HIGHWAY LIGHTING LEGEND
& KEY MAP

INTERSTATE ROUTE H-1 REHABILITATION
MIDDLE STREET TO VICINITY OF WARD AVENUE
FAP NO. 1M-HI-1(269)

"AS-BUILT"

HIGHWAY LIGHTING PLAN - A

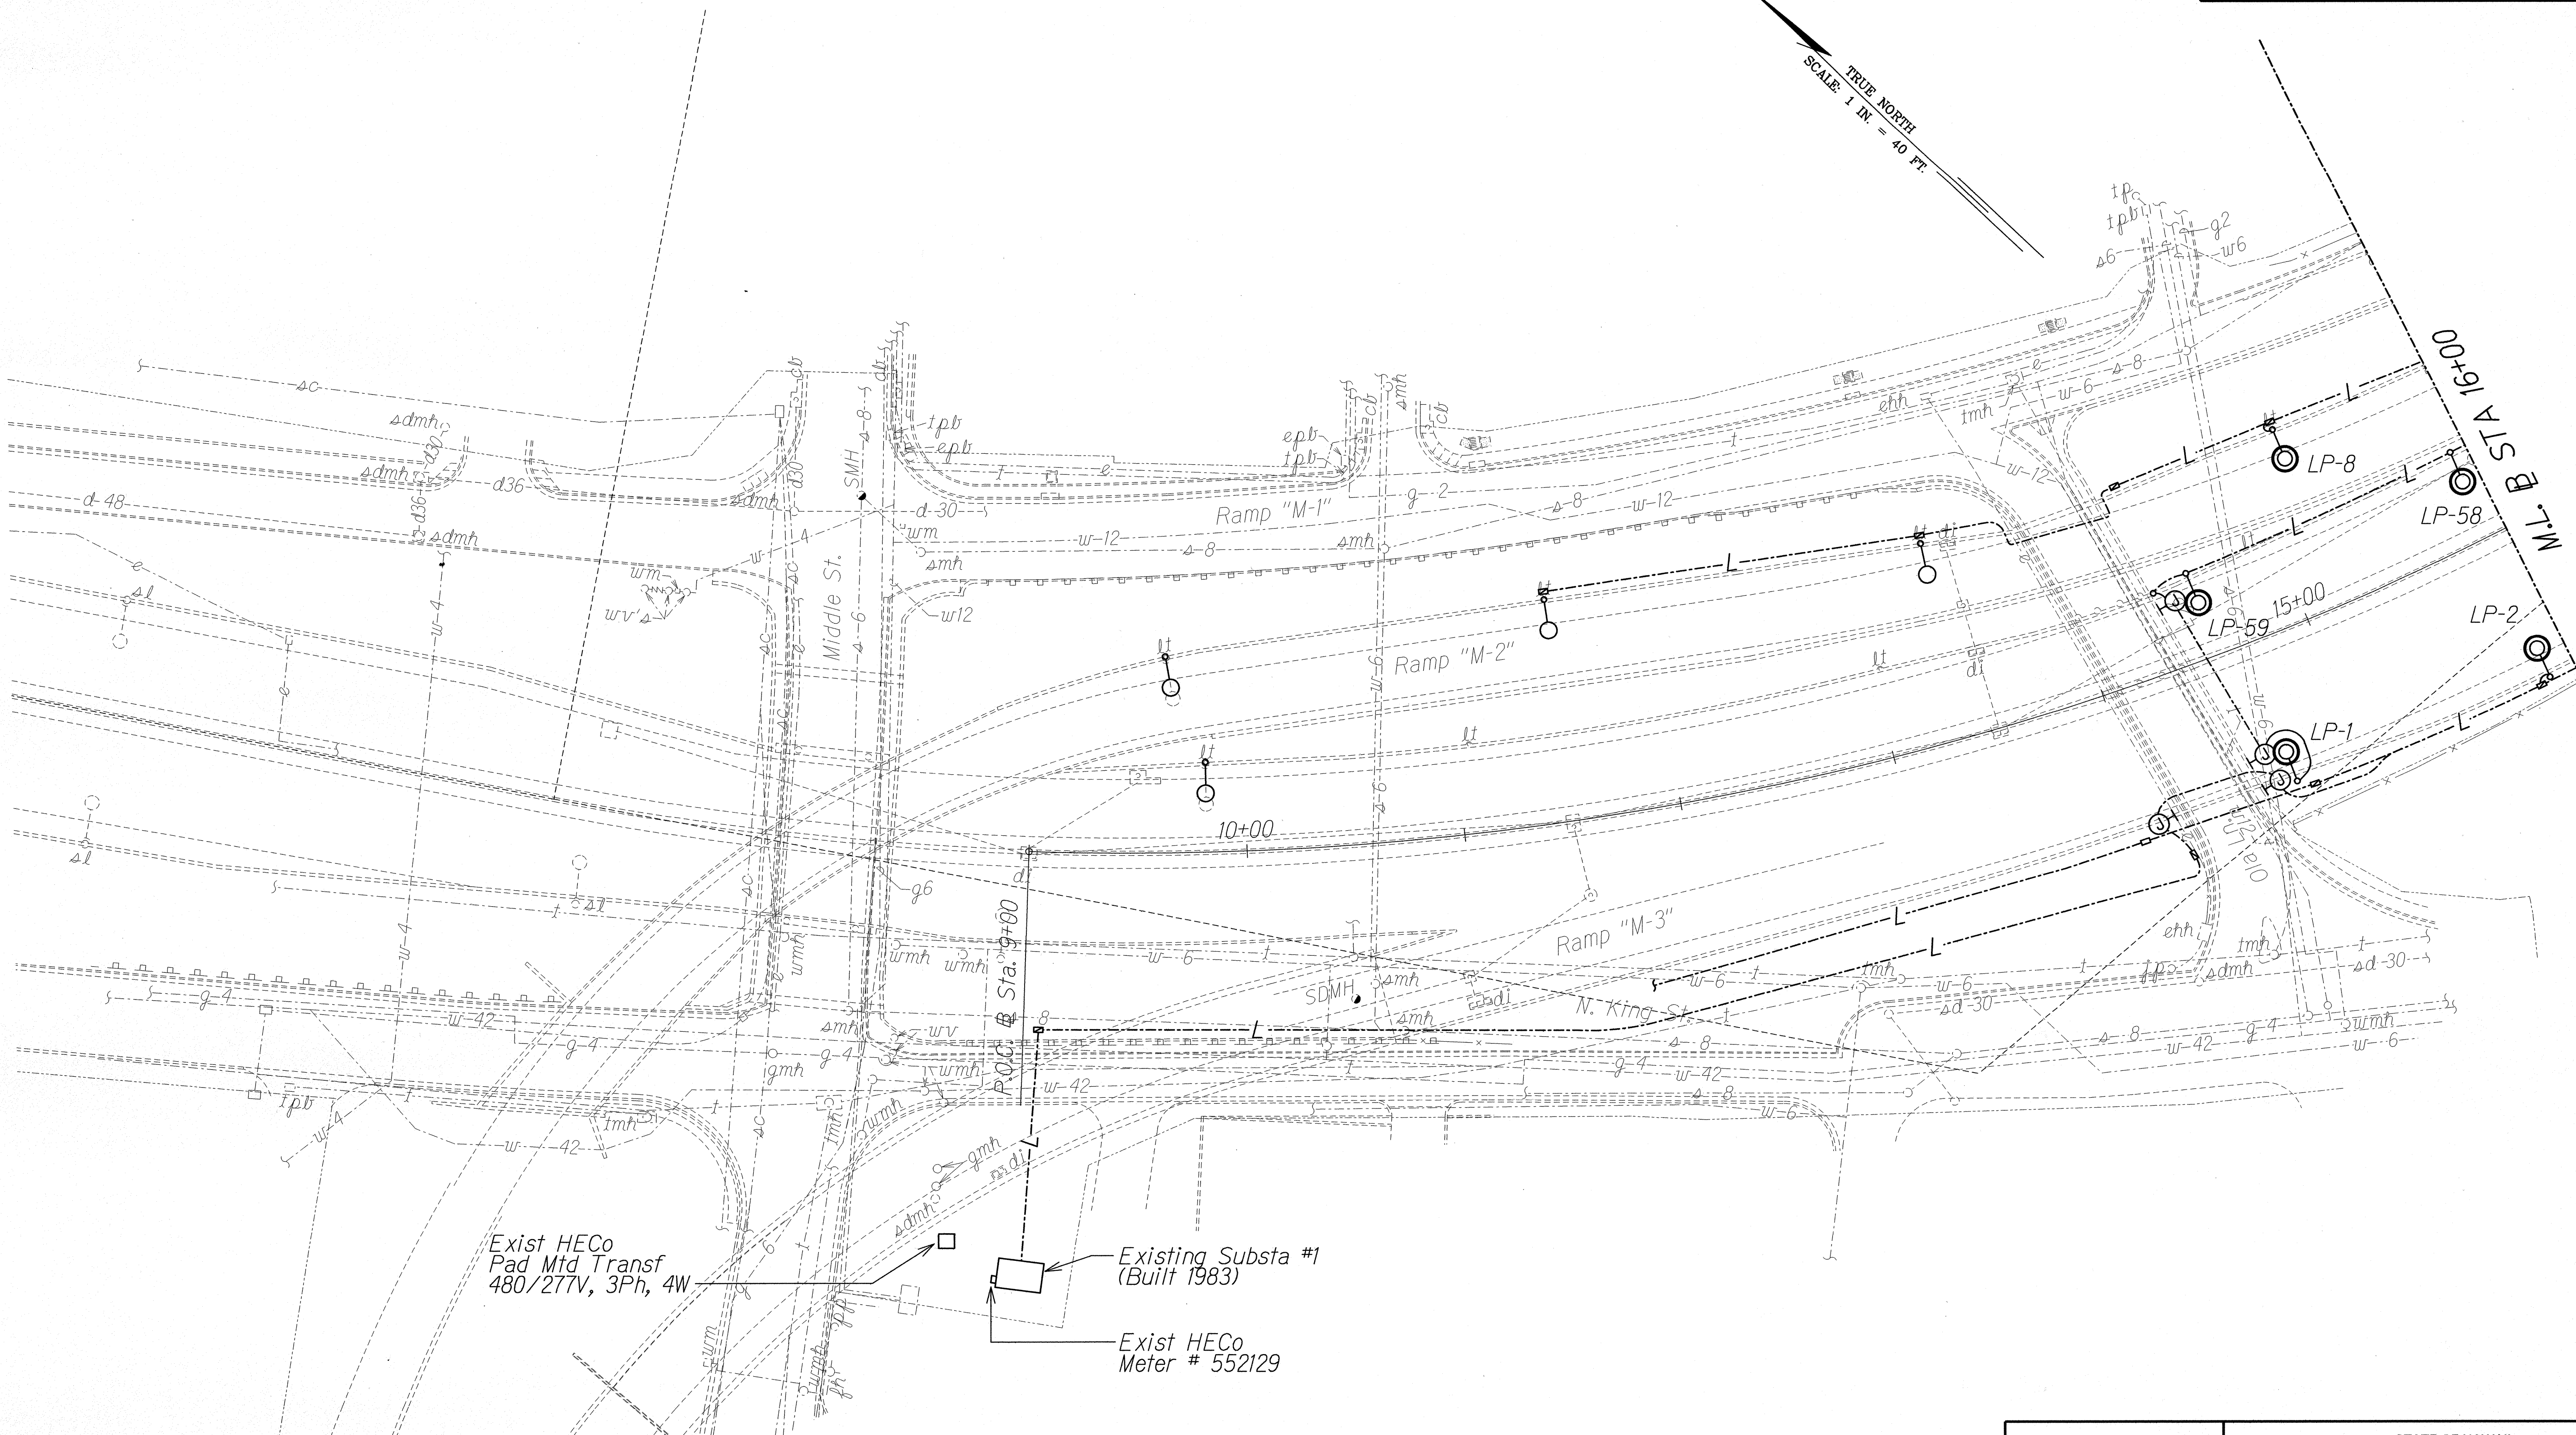
Highway Lighting Installed on Overpass instead of Trenching in the Roadway Shoulder. (Per RFI 053).

HIGHWAY LIGHTING PLAN - B

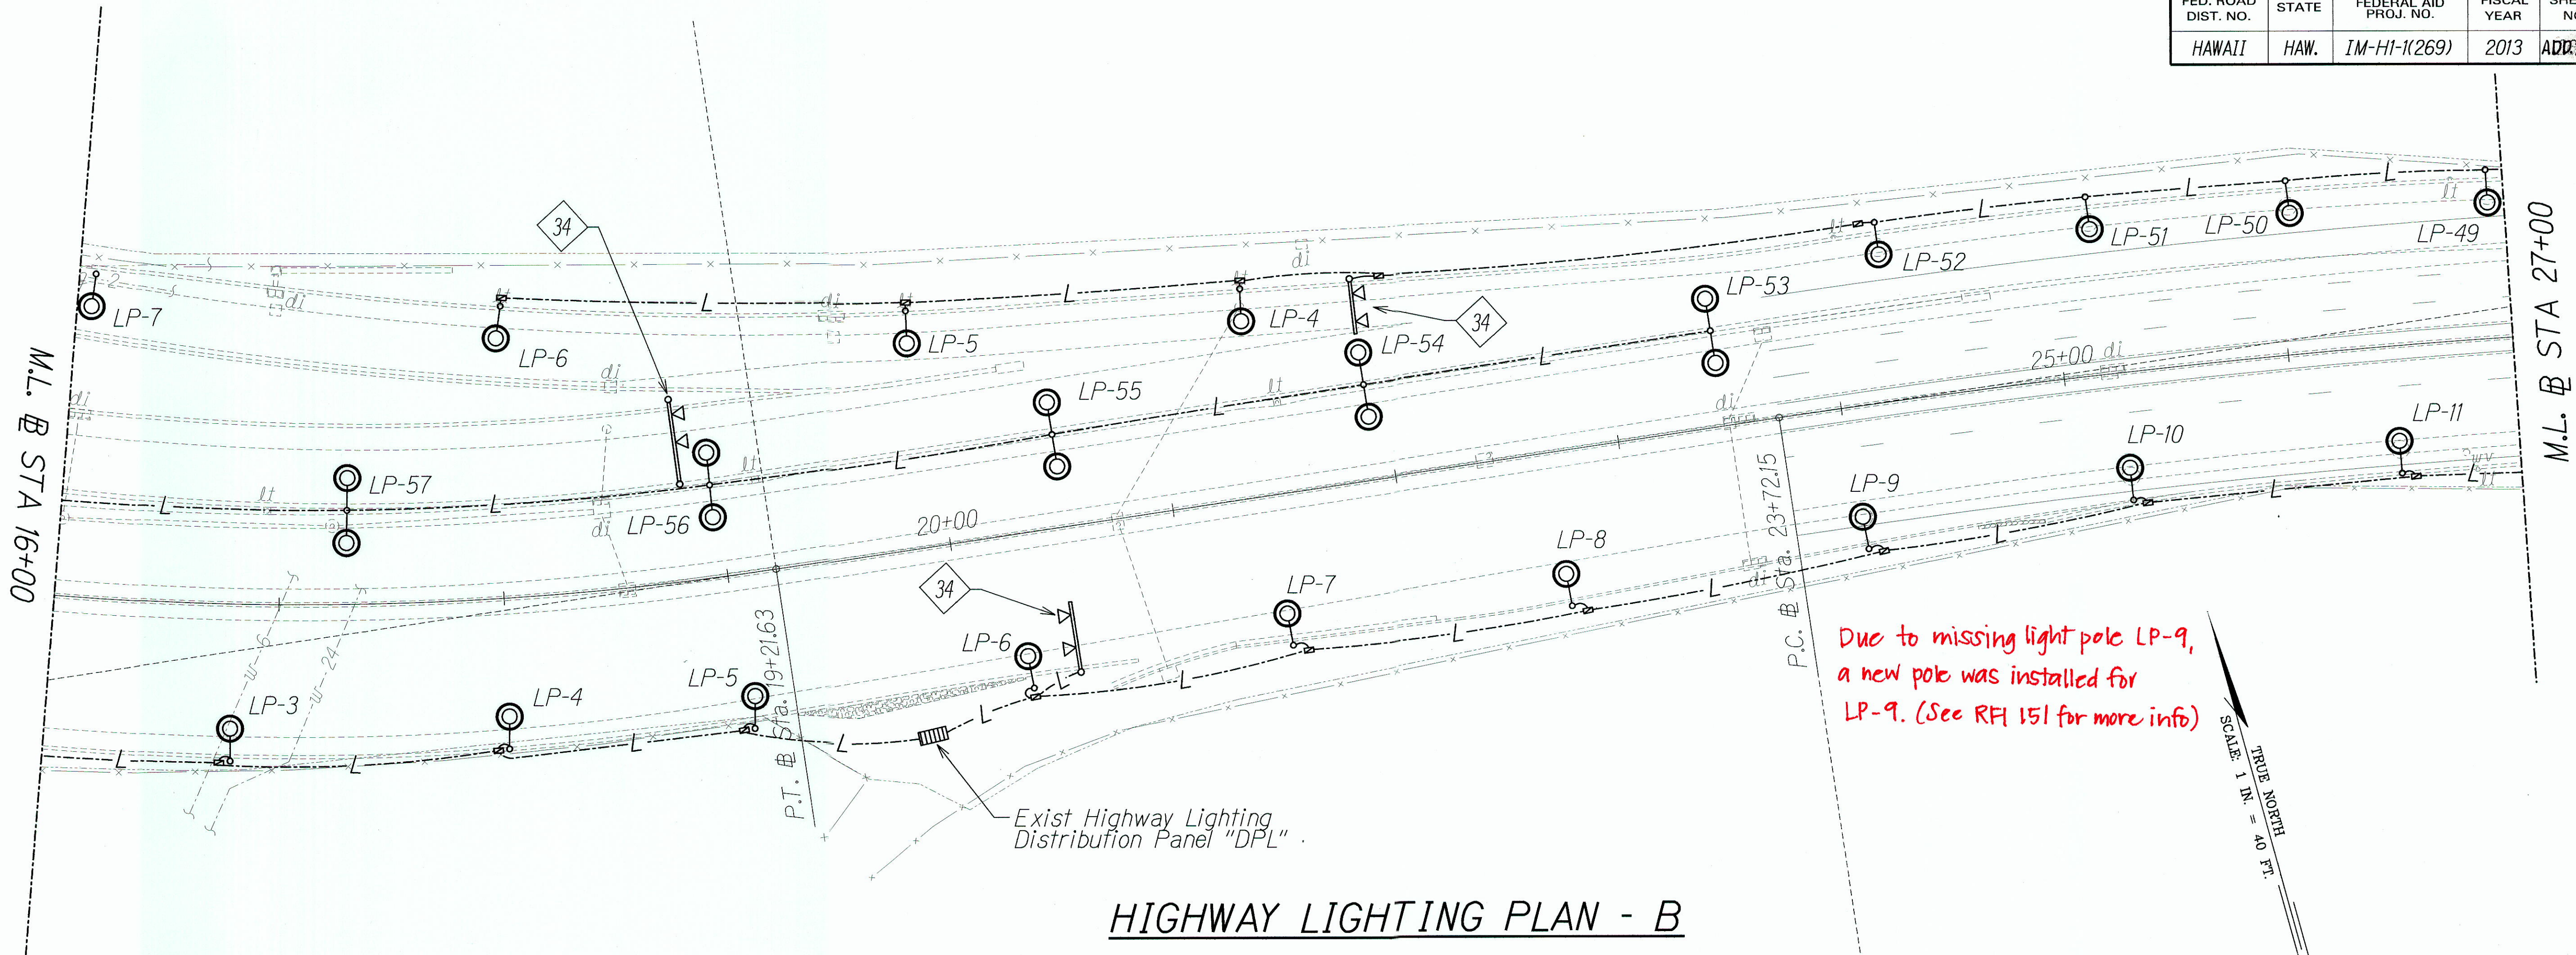
Due to missing light pole LP-9, a new pole was installed for LP-9. (See RF 151 for more info)

HIGHWAY LIGHTING PLAN - E

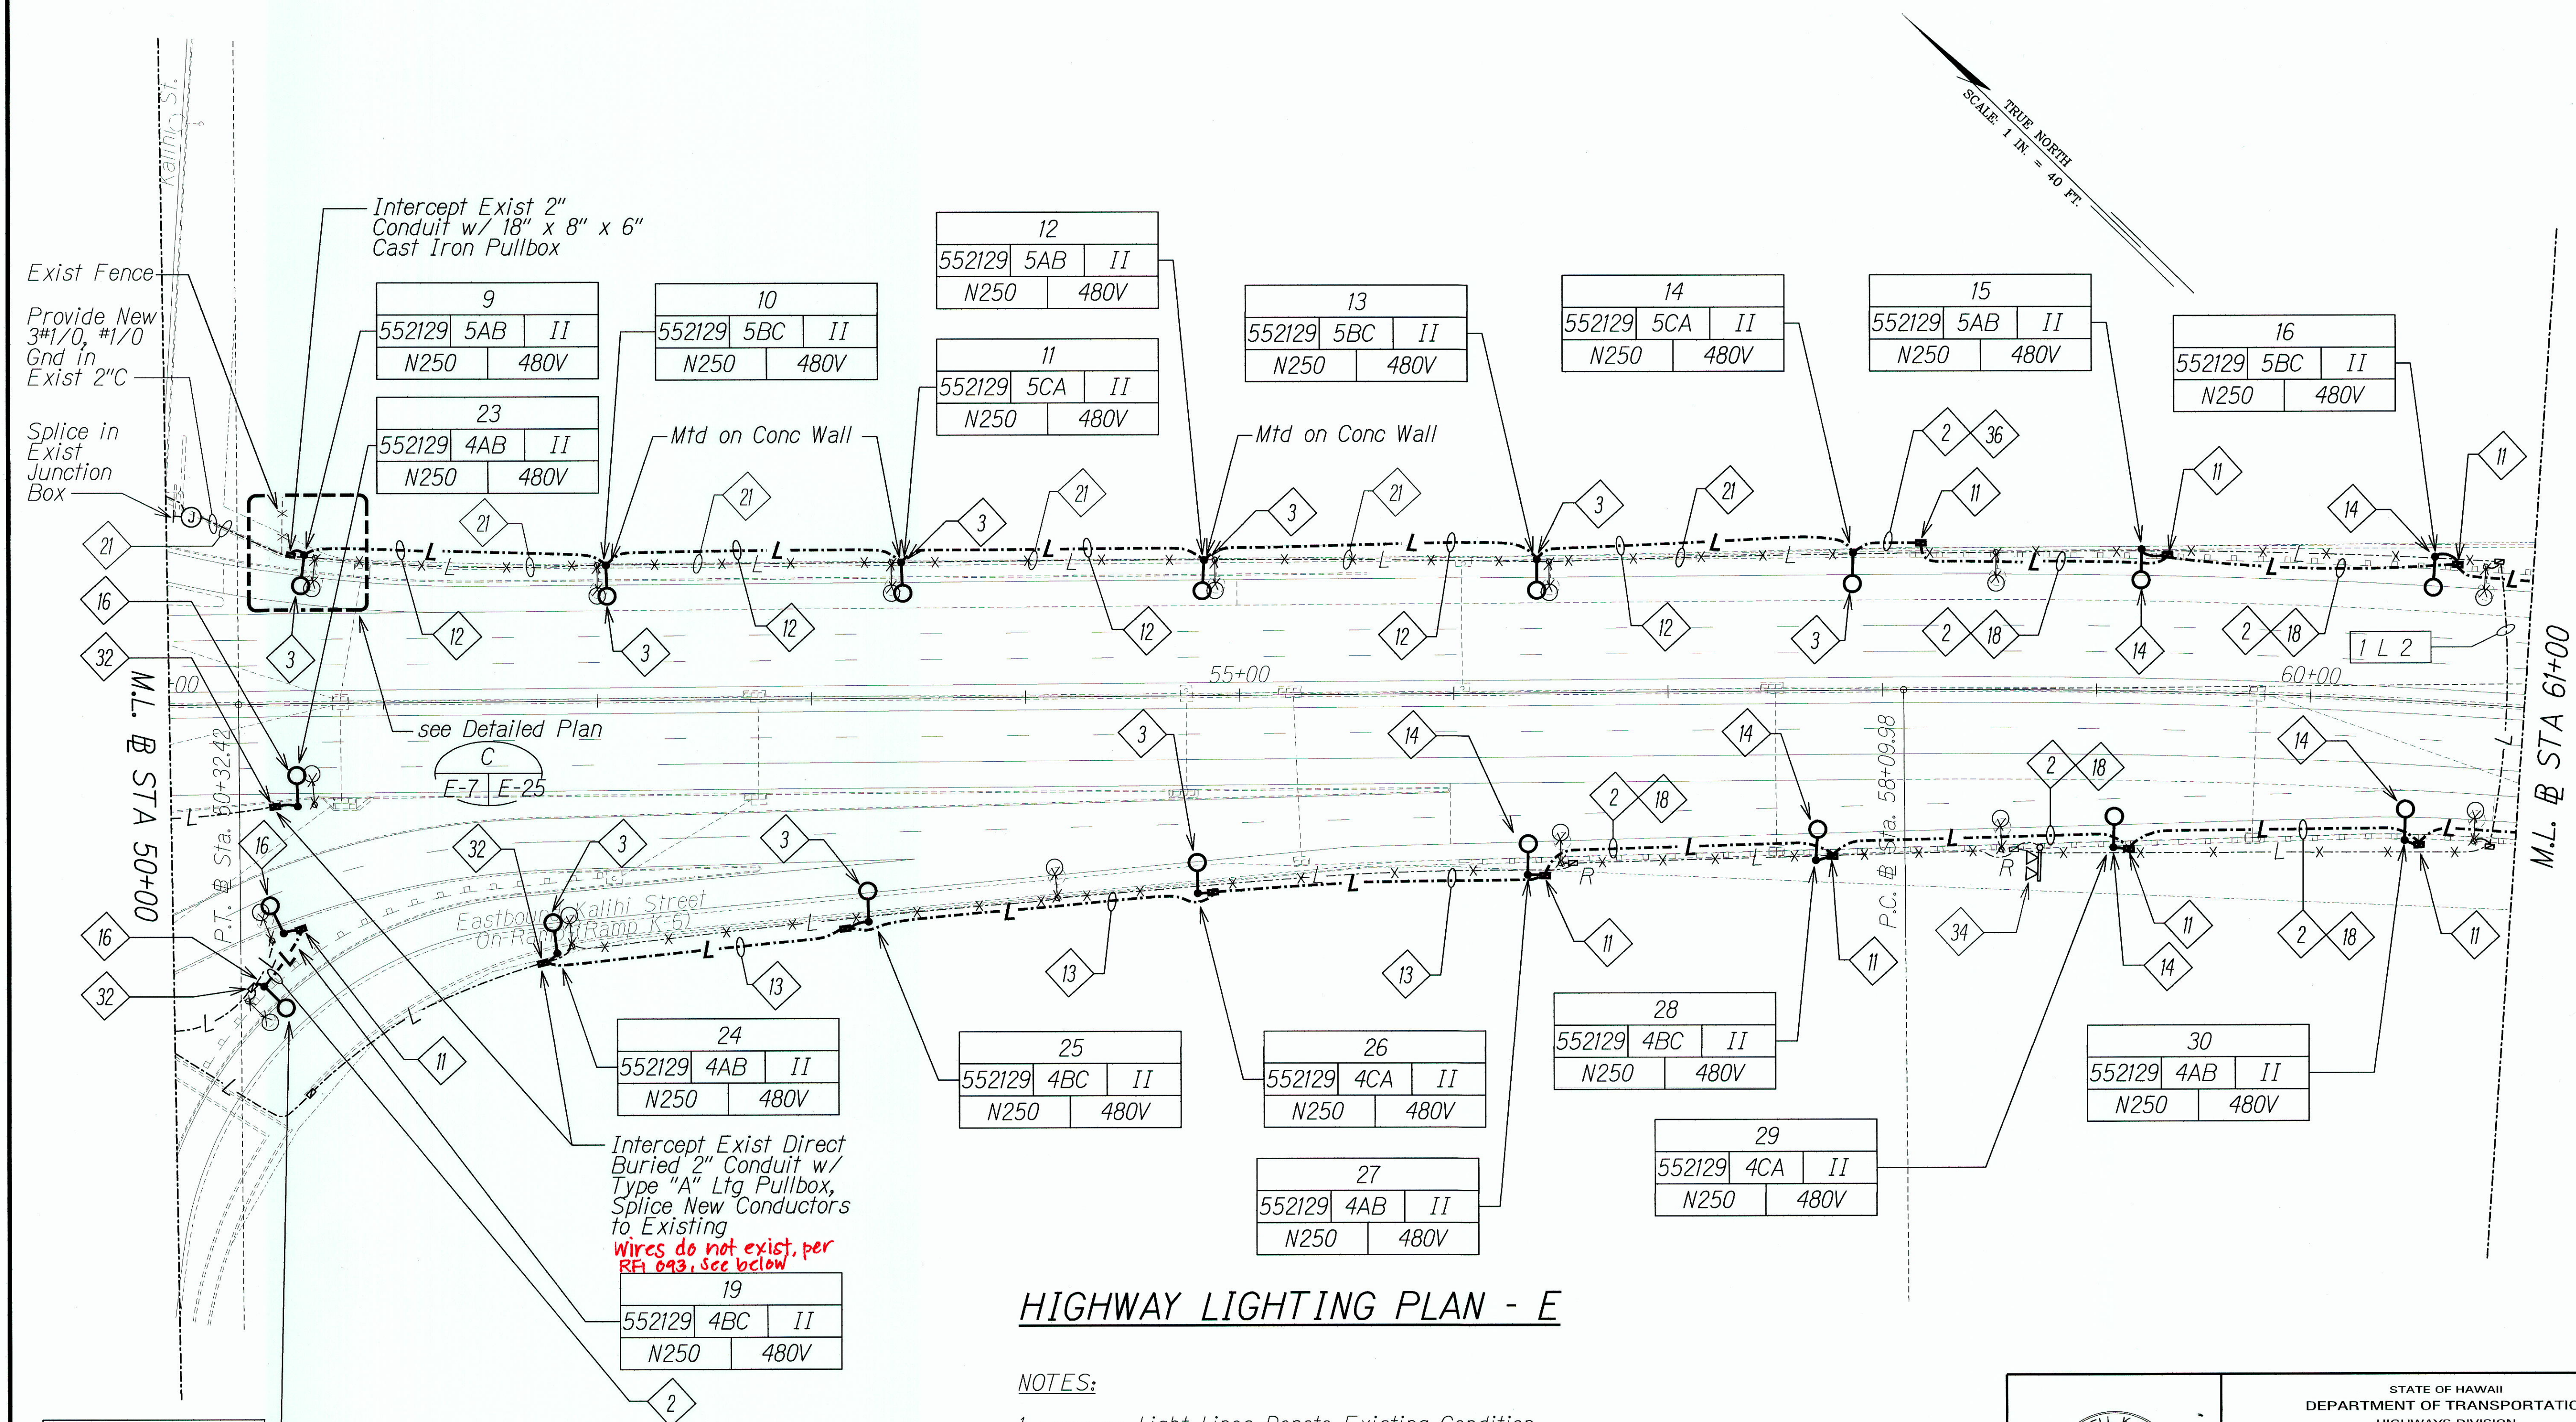
New Ductlines (2'C, 3# 1/0, # 1/0 GND) extend from Pullbox Adjacent to Pole 24 and connect to existing Pullbox Adjacent to the Bridge Crossing Ramp K-G.
